PIC24F16KA102 Family Silicon Errata and Data Sheet Clarification

The PIC24F16KA102 family devices that you have received conform functionally to the current Device Data Sheet (DS39927B), except for the anomalies described in this document.

The following typographic corrections and clarifications are to be noted for the latest version of the Device Data Sheet (DS39927B):

FIGURE 1: PIN DIAGRAMS

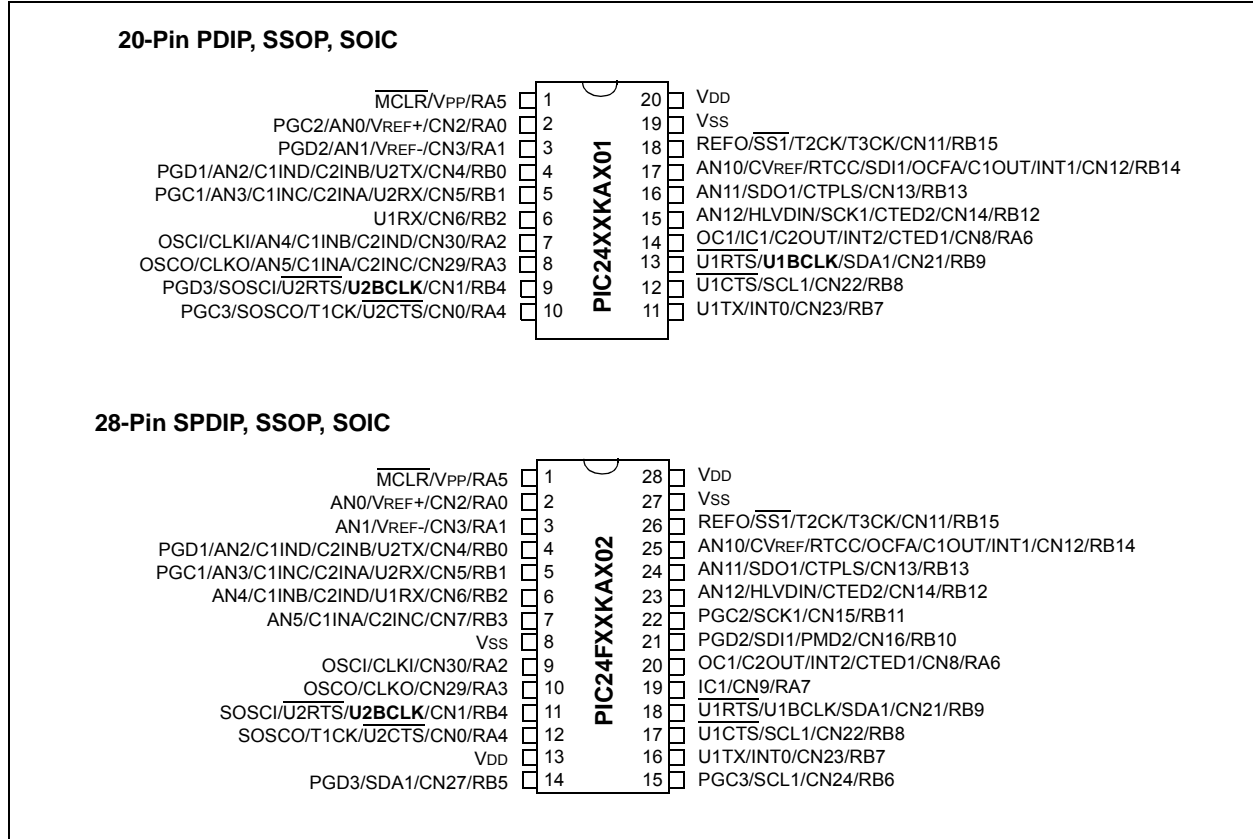
In many places in the data sheet, the UART Baud Clock output functions, U1BCLK and U2BCLK, are shown as being multiplexed on the same pins as the UART Receive input functions (U1RX and U2RX). The Baud Clock is actually multiplexed with the UART Ready-to-Send output function (U1RTS and U2RTS) on completely different pins. This mapping is correctly described in the UART chapter, but incorrectly shown on pin diagrams and pin function listings.

The pin diagrams from the data sheet are replaced by the pin diagrams shown in [Figure 1](#), [Figure 2](#) and [Figure 3](#). Changes are noted in bold. Footnotes present in the original diagrams have been omitted here for clarity.
